## **STAFF REPORT ADDENDUM II**

**SPECIAL EXCEPTION APPLICATION SE 2008-PR-021**

**PROPOSAL:** To permit a child care center and nursery school with a maximum enrollment of 150 students.

**CONCEPT**  
LANDSCAPE PLAN

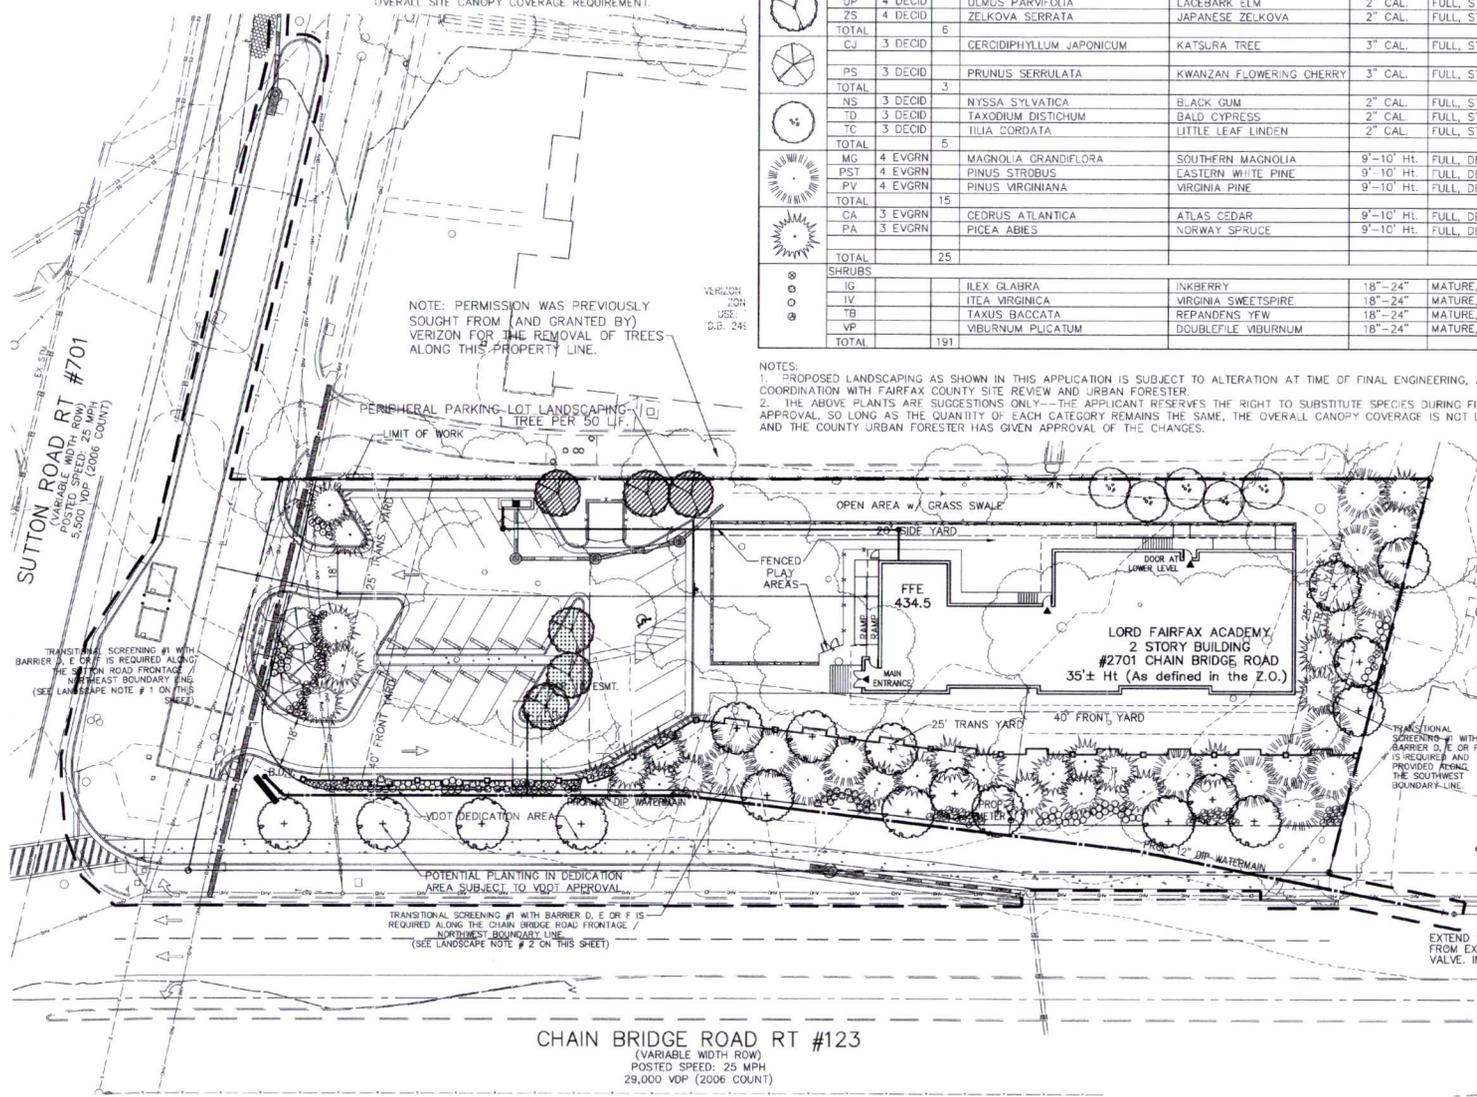
- 6. Comment:** Golden raintree and Austrian spruce are proposed to be planted as specified in the Preliminary Plant List on sheet 5. Golden raintrees have prolific seeds and Austrian pine trees are susceptible to diplodia canker. These trees are undesirable and not suited for this environment.

- 7. Comment:** The 3" caliper size specification provided for the proposed evergreen trees as specified in the Preliminary Plant List on sheet 5 is incorrect.
